SECTION 8.00-9.00 Planning Pre-App’s DM/23/1480 & DM/25/0133

Responses to and Comparables with Current Full Planning/Listed Building Consent Applications

8.00 Pre App DM/23/1480 and Current Proposal Responses & Comparables

8.04 New Leisure Facilities - Pool/Spa/Gym/ Yoga: Lower Ground / Ground Floor (nts)

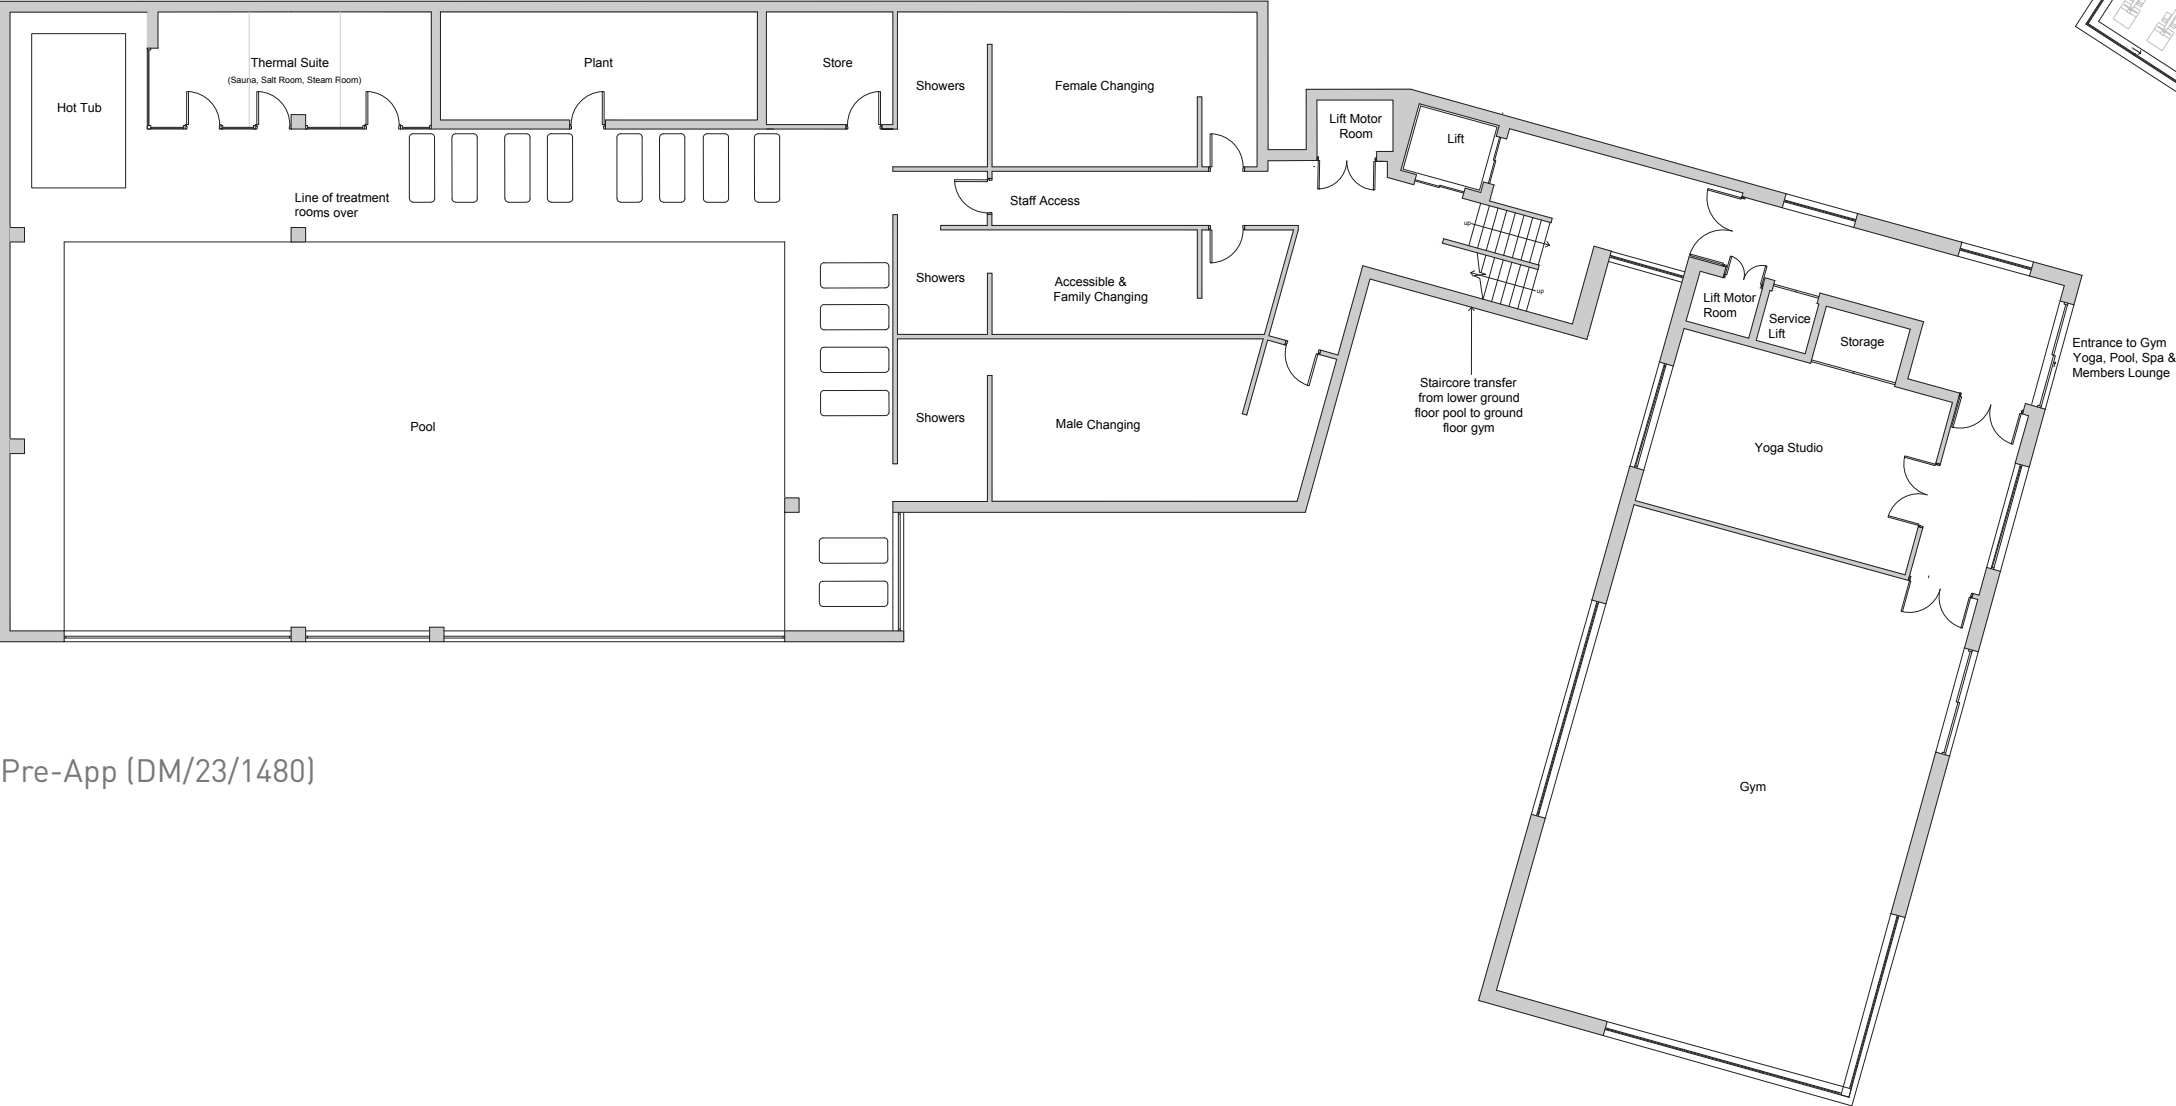
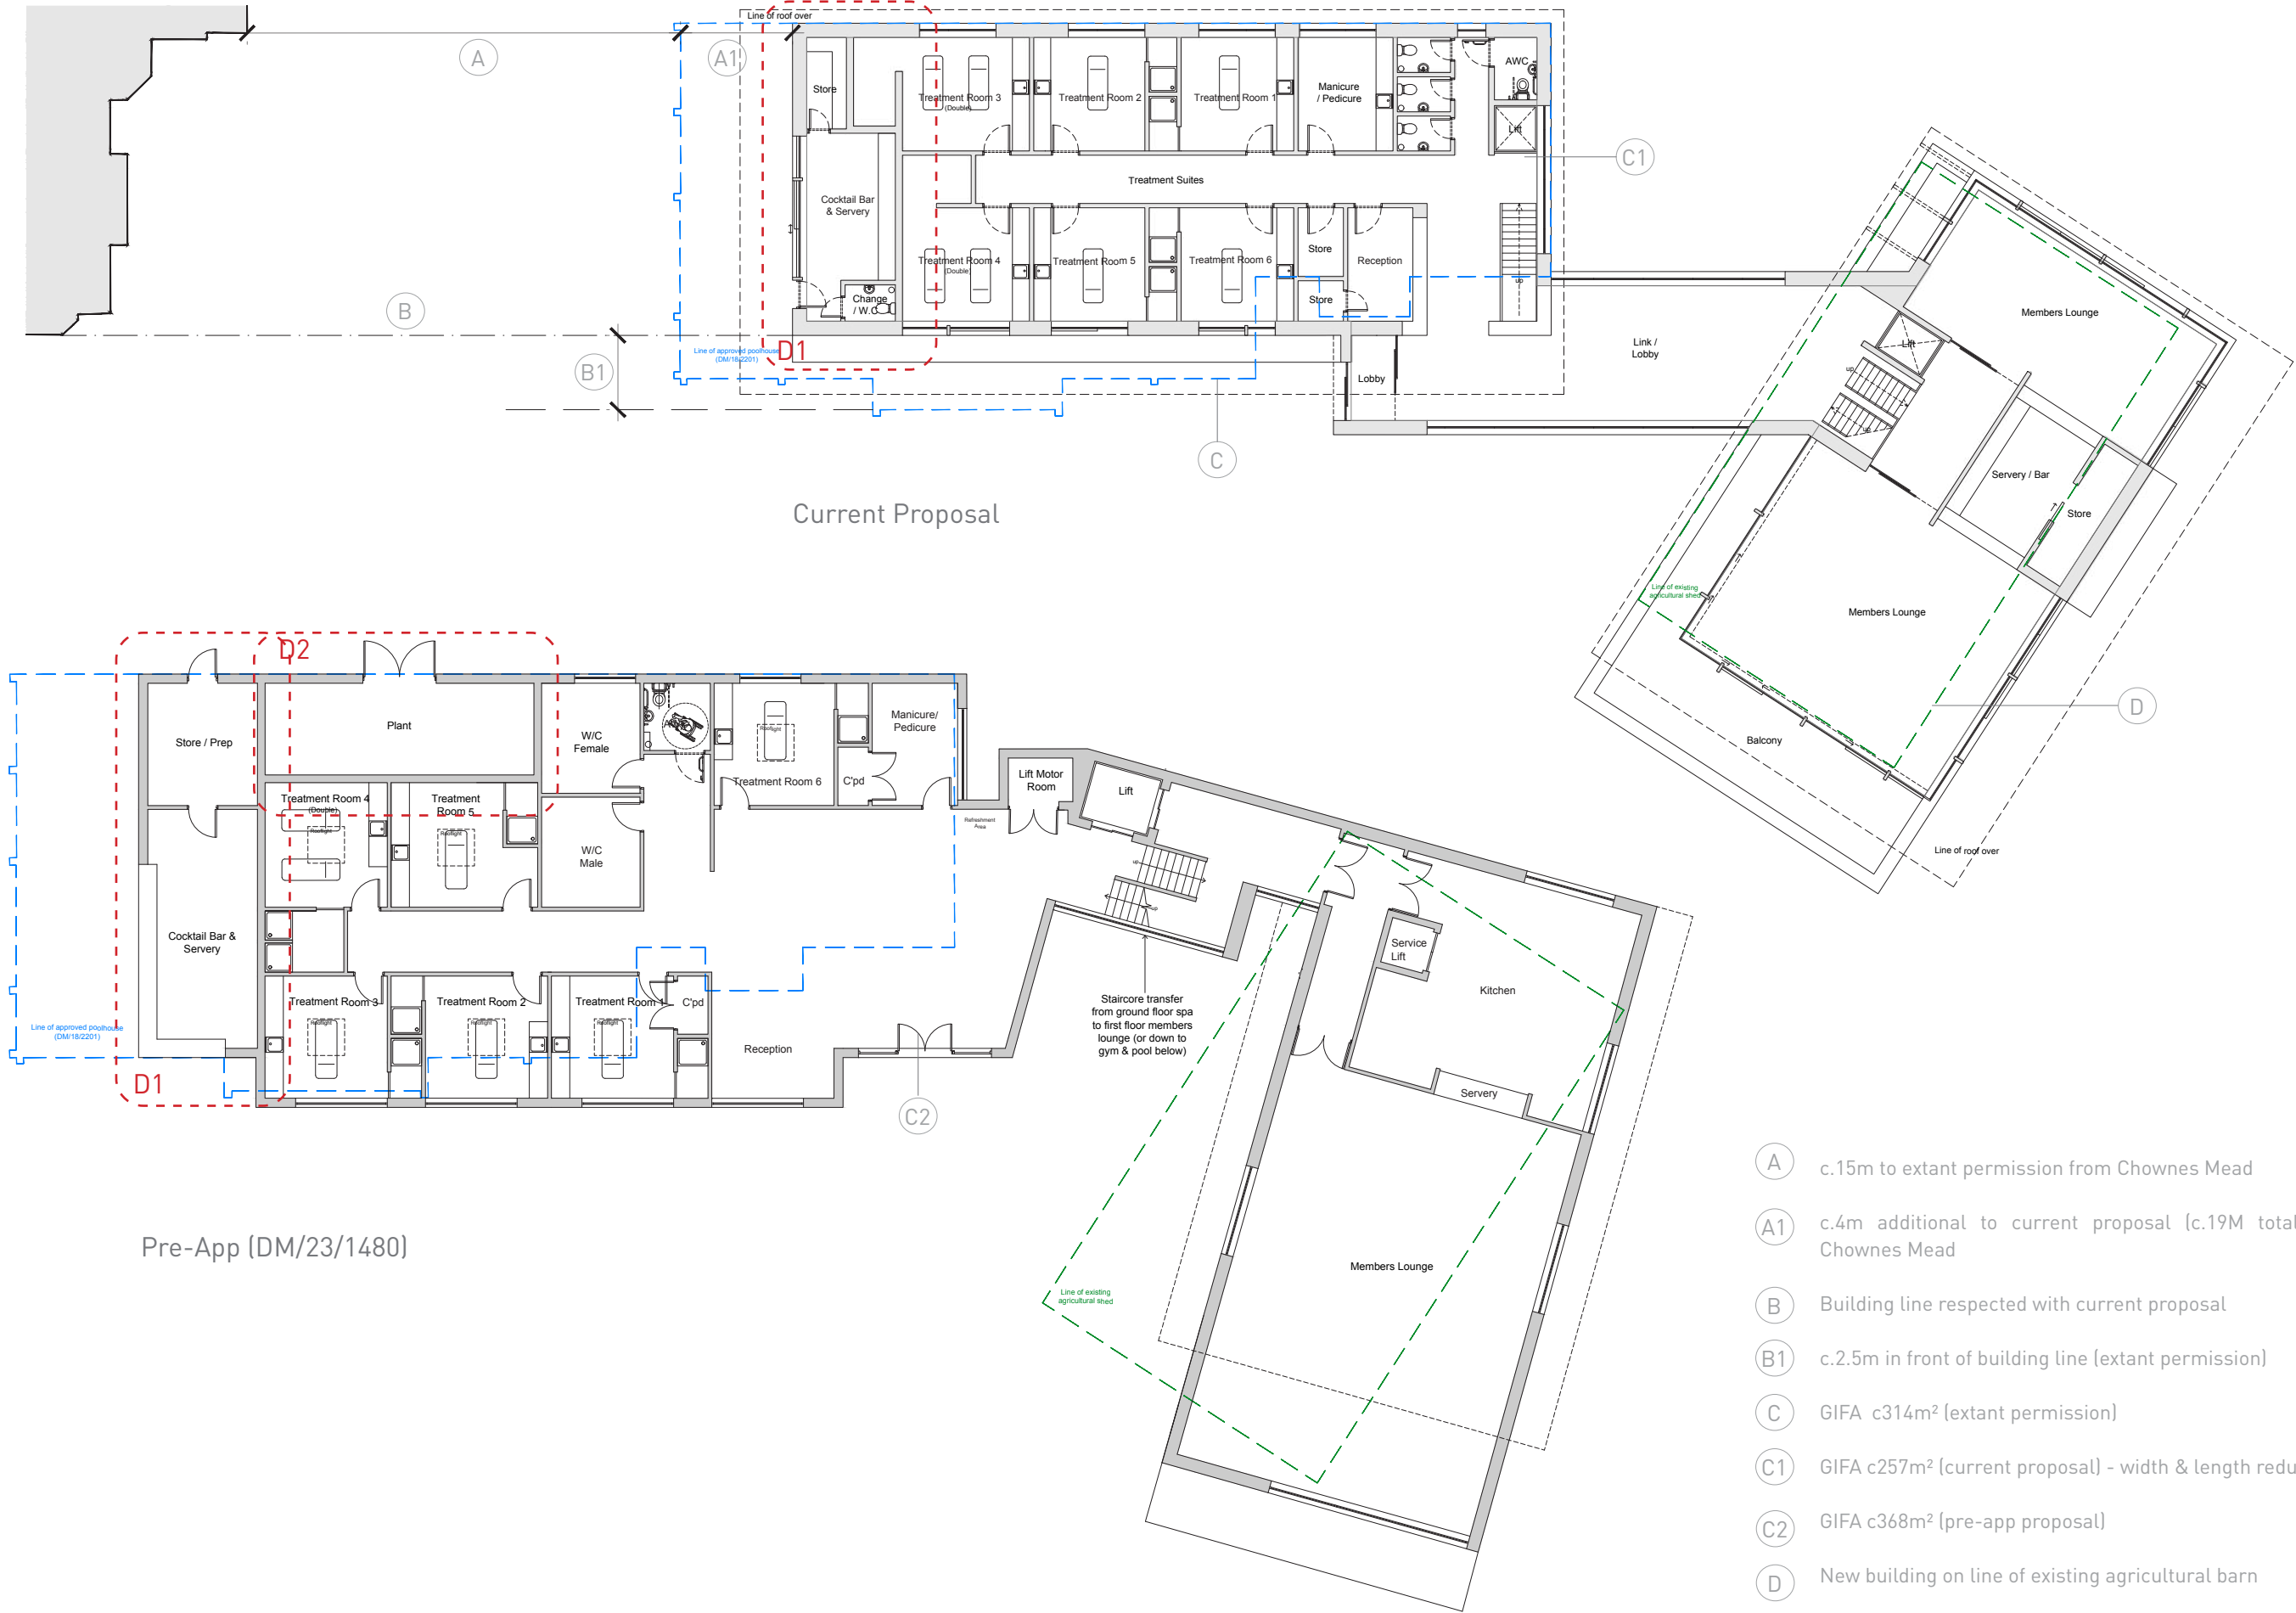
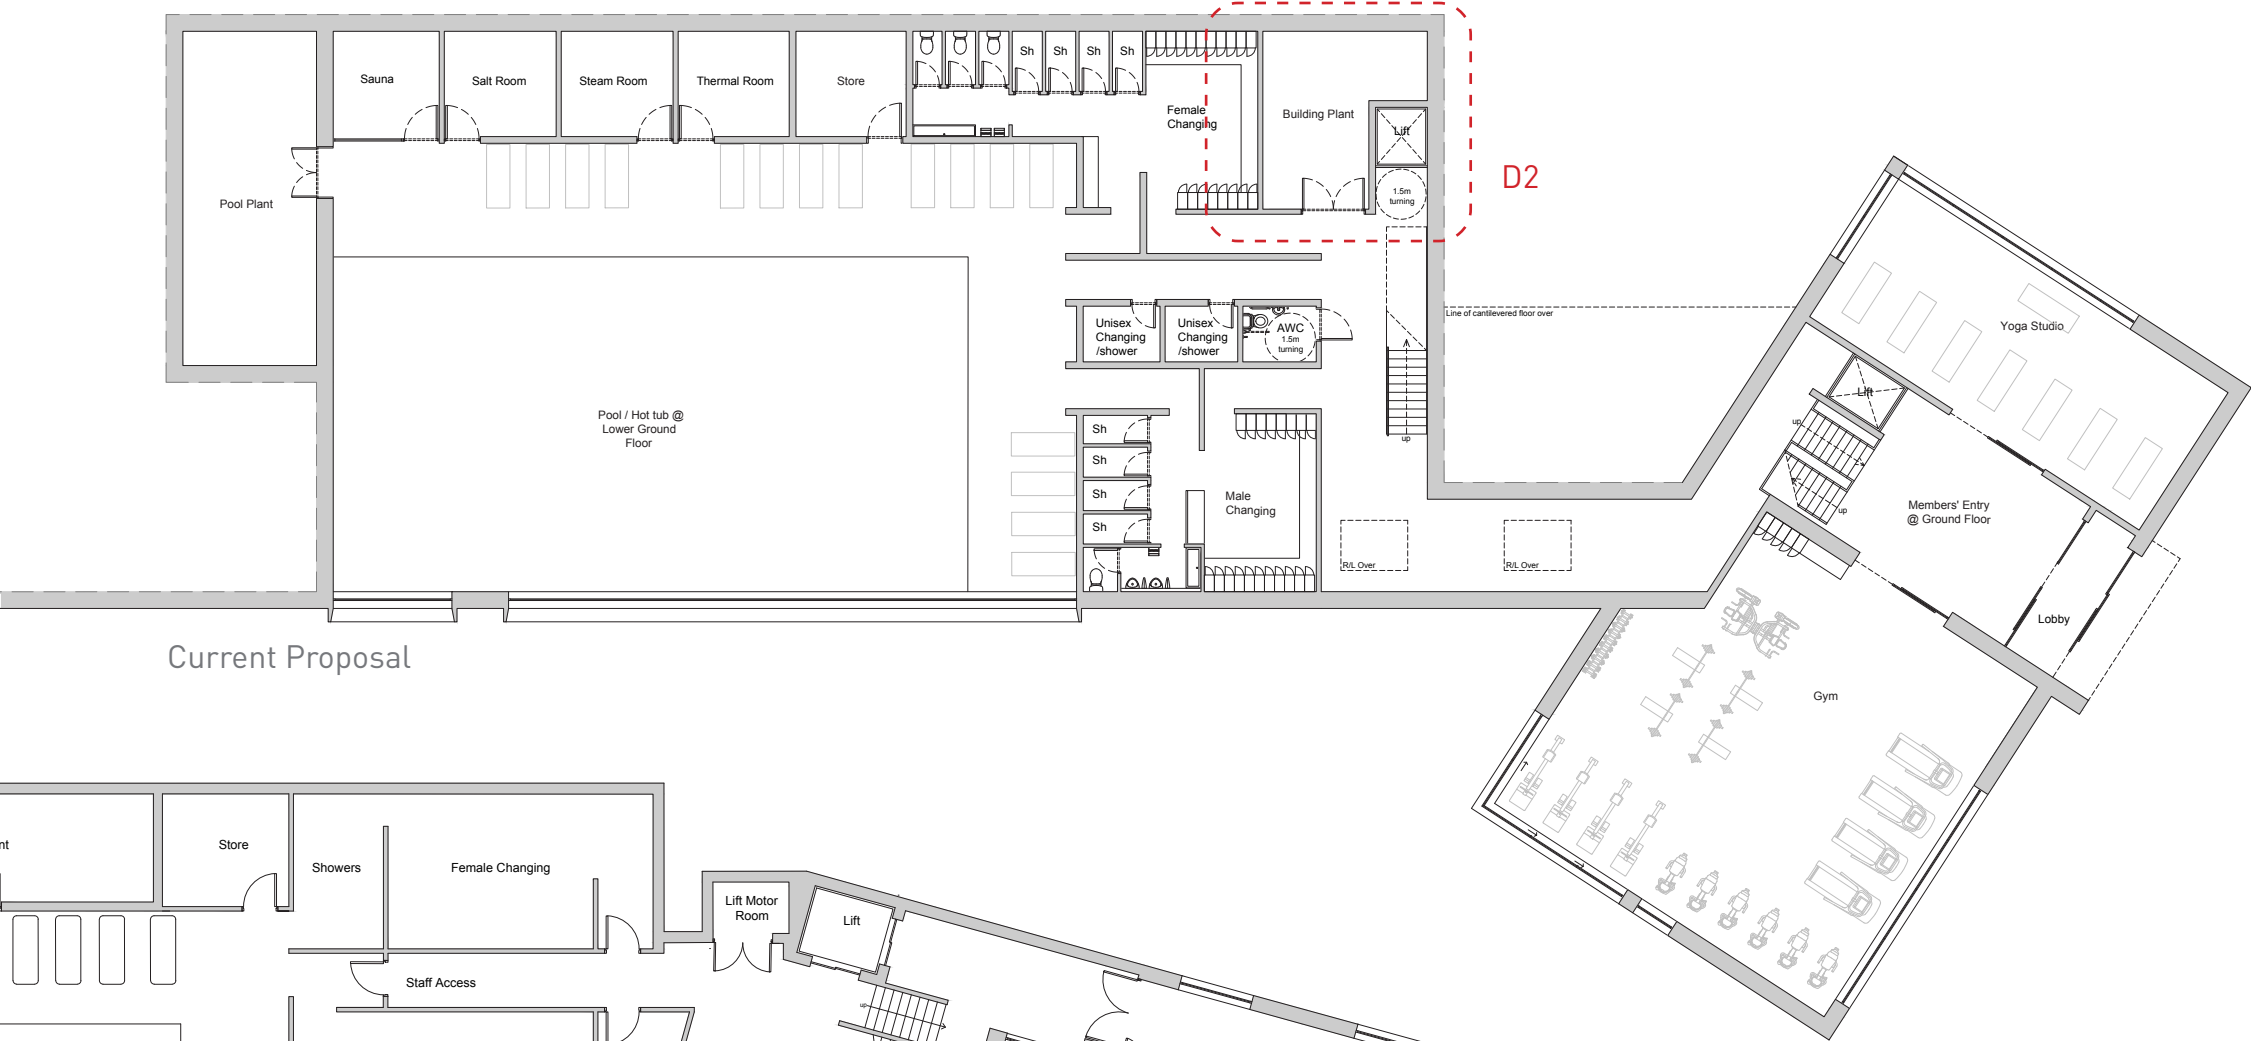
D1
‘The proposed two storey pool and treatment room building is a more substantial structure than the approved pool house. However, the building is set further away from the listed house, creating greater separation between the two, and the additional storey is set below the terrace, taking advantage of the drop in the levels of the gardens to the south west of the house.’
‘In my opinion, this approach is not necessarily contentious in principle, but the building and surrounding landscaping will require very careful planning and detailing, including the choice of materials, to minimise the bulk and visual prominence of the development in the context of the house, ensure that it complements rather than detracts from the house and its setting, and to preserve the character of the Jekyll designed gardens, including the existing listed terrace walls. The submitted visuals, which I appreciate are only conceptual, show for example a rather stark treatment of the retaining wall to the north west of the pool house itself, continuing along the house’s garden frontage. We would expect a more sensitive treatment with appropriate detailing and planting to blend the built form into the landscape, and not to detract from or compete with the original listed terrace walls. I also wonder whether the cocktail bar and servery to the north west end of the ground floor of the building is necessary in this form and position, particularly given the proximity of the house, or could be omitted or relocated to reduce the bulk of the building.’

D2
‘Firstly, I do have concerns about the potential noise generated by the plant associated with the spa and gym. To adequately assess this issue, we would require detailed information about the proposed plant, its location, whether it is internal or external, and any measures that will be implemented to mitigate noise. Depending on the expected noise breakout, we may need to request an acoustic report to ensure that the noise levels will not adversely affect the surrounding area.’

D1
Subservience & Separation
As noted in the pre-app response, the upper level of the proposed spa and pool building is set c.4M further away from the listed building than the extant permission. The intention is to create a greater separation between existing and new build elements, reinforcing the subservience of the new buildings, the current proposal widening this gap to c.19M overall.

D2
The refined and reduced layout of the treatment suites and pool / spa building has enabled a reworking of the plant areas which were positioned towards the north west end of the building at the upper floor level in the pre-app submission. The current layouts propose repositioning this element below ground to the south eastern end of the building to mitigate any noise breakout impacts from the plant area that would potentially impact the guests of the listed building or neighbours.
